ACCESS REPORT

SYDNEY ADVENTIST HOSPITAL

ENVIRONMENTAL ASSESSMENT

PART 3A – PROJECT APPLICATION

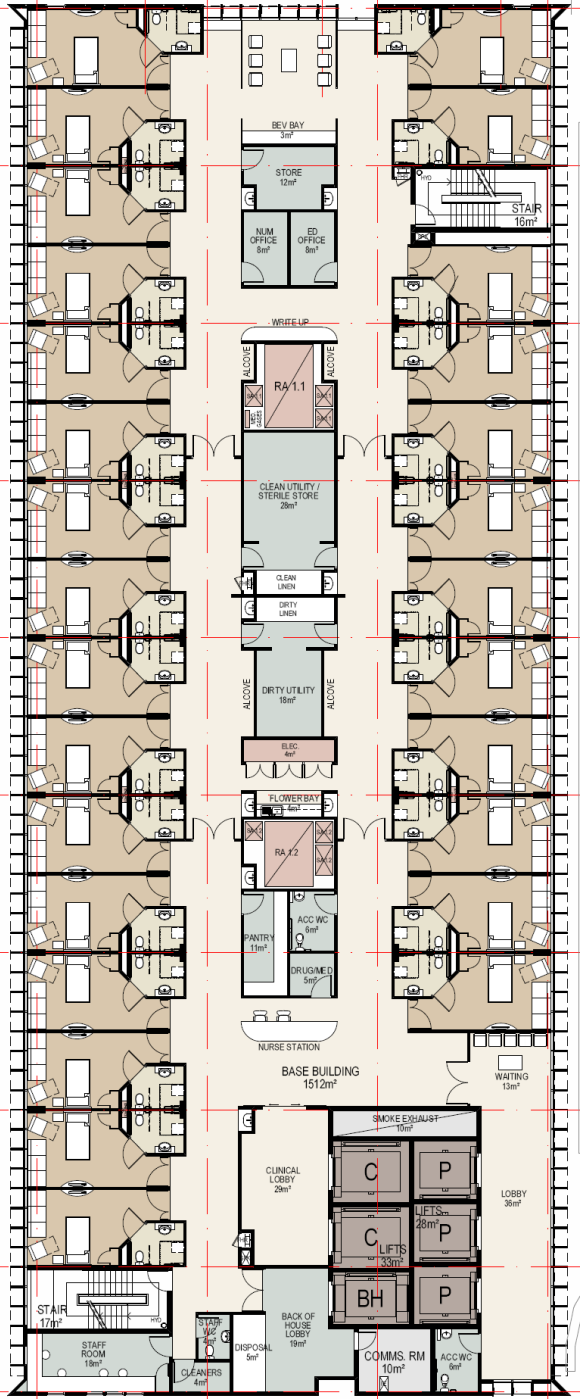
<p>Shannon Car Park (Stage 3)</p> <p>18. The four (4) level Shannon Car Park shall provide 230 spaces and will be required to provide at least five (5) accessible parking spaces to satisfy Table D3.5 of the BCA, which can be confirmed at the construction certificate stage.</p>  <p>19. With respect the provision of accessible path of travel from the car park the construction certificate plans shall confirm a lift within the car park and a level corridor link into the adjoining Shannon Wing building at Level 3.</p>	<p>YES at CC stage</p> <p>YES at CC stage</p>

Level 2 Podium Entry and Parking

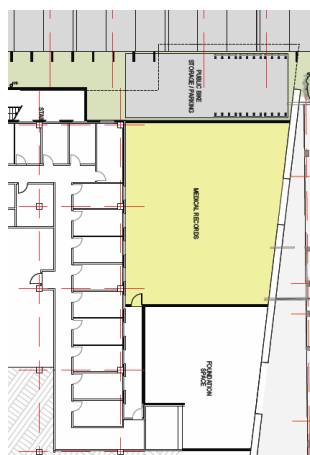
BCA / DDA Compliance	Complies
58. Principal Entry Access - The Stage 2 additions shall provide a new principal entry to the hospital providing on-grade level access from the vehicular drop-off point and car park at Level 2.	YES
59. Level 2 entry will provide level transitions to adjoining buildings and the ramped concourse to the existing Clifford Wing to facilitate easy access throughout to comply with AS1428 parts 1 and 2, Parts D3.2, D3.3 of the BCA, DCP 31 and the DDA.	YES

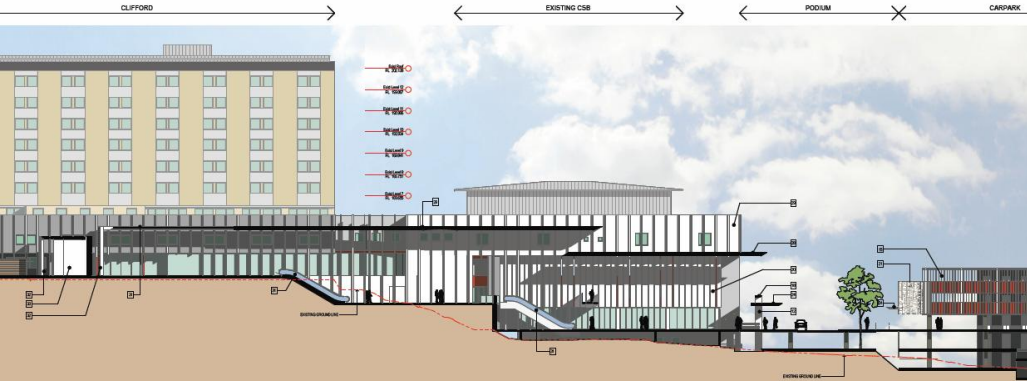
BCA / DDA Compliance	Complies
<p>Parking Overview</p> <p>60. Stage 2 parking shall provide 164 parking spaces situated adjacent to the new Concourse (134) and various roadways within the hospital site (30).</p> <p>61. There will be 22 accessible spaces at level 2 which will be designed in accordance with AS2890.1/AS2890.6 to comply with Part D3.5 of the BCA and the DDA.</p> <p>62. Other parking on roadways shall not be accessible due to the steepness of roads and other design restrictions. Regardless the 22 accessible spaces will satisfy accessible parking requirements.</p>	YES

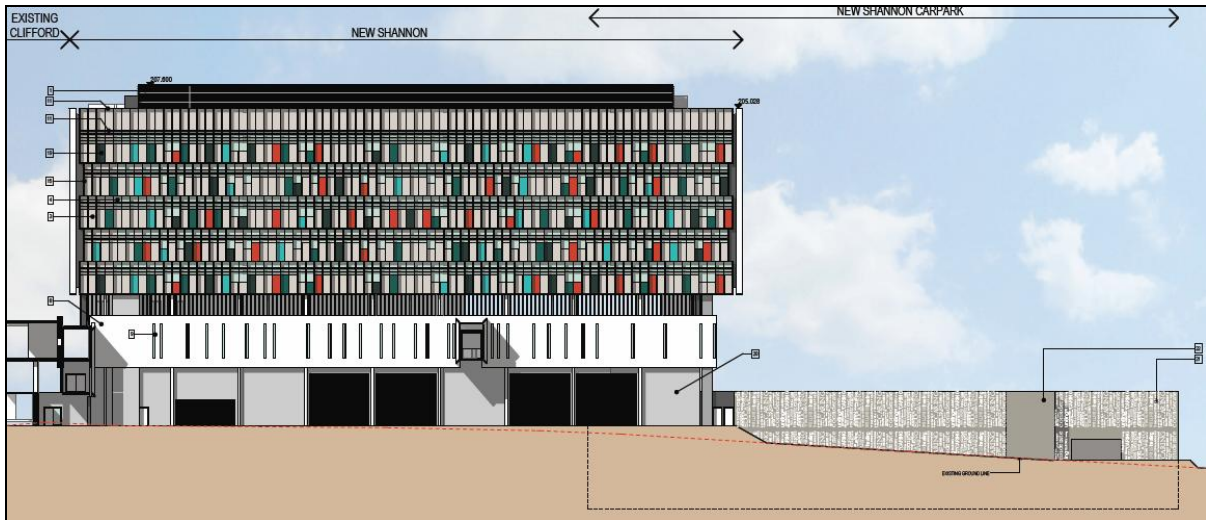
87. These unisex accessible toilets can provide at least 3000mm X 2000mm, or 2400mm X 2400mm in accordance with AS1428.2, Part F2.4 of the BCA and DCP 31 and the DDA.	 <p>The diagram is a floor plan of a sanitary facility. It shows a central corridor with several rooms branching off. On the left side, there are 'MALE AMENITIES' and 'FEMALE AMENITIES'. On the right side, there is a 'DIS WC' (disabled toilet) and 'STAFF AMENITIES'. At the top, there is a 'STORE' and a 'CL' (closet). The plan includes symbols for toilets and sinks, and shows the layout of the rooms and their relative positions.</p>	YES at CC stage

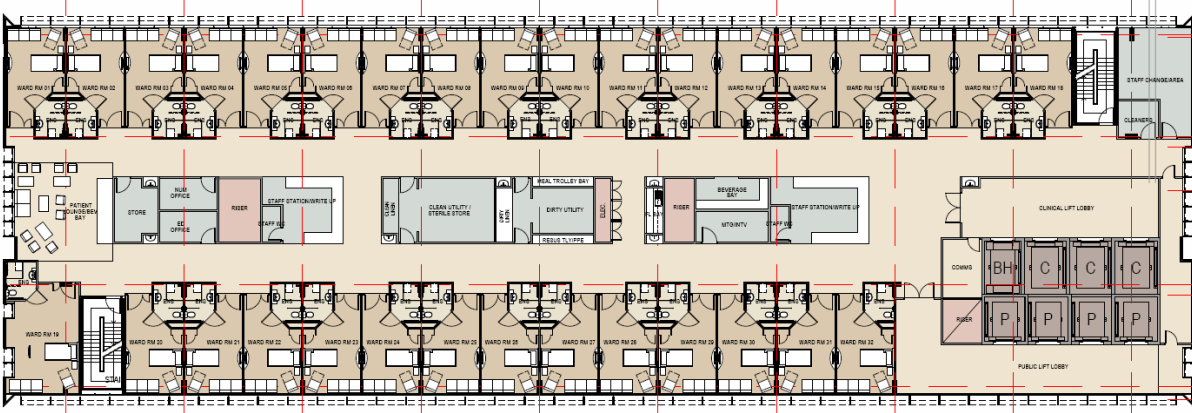
BCA / DDA Compliance	Complies
access to the principal entrance within the Clifford Wing at level 4.	
90. Level 3 shall also facilitate on-grade access to the adjoining outdoor dock areas and Shannon car park.	YES
91. Integral to the accessibility of the Shannon Wing is the provision of eight (8) lifts and balcony links to the CSB building at levels 4 and 5, which will facilitate appropriate access to all areas to comply with ASI428 parts 1 and 2, Parts D3.2, D3.3 of the BCA, DCP 31 and the DDA.	YES
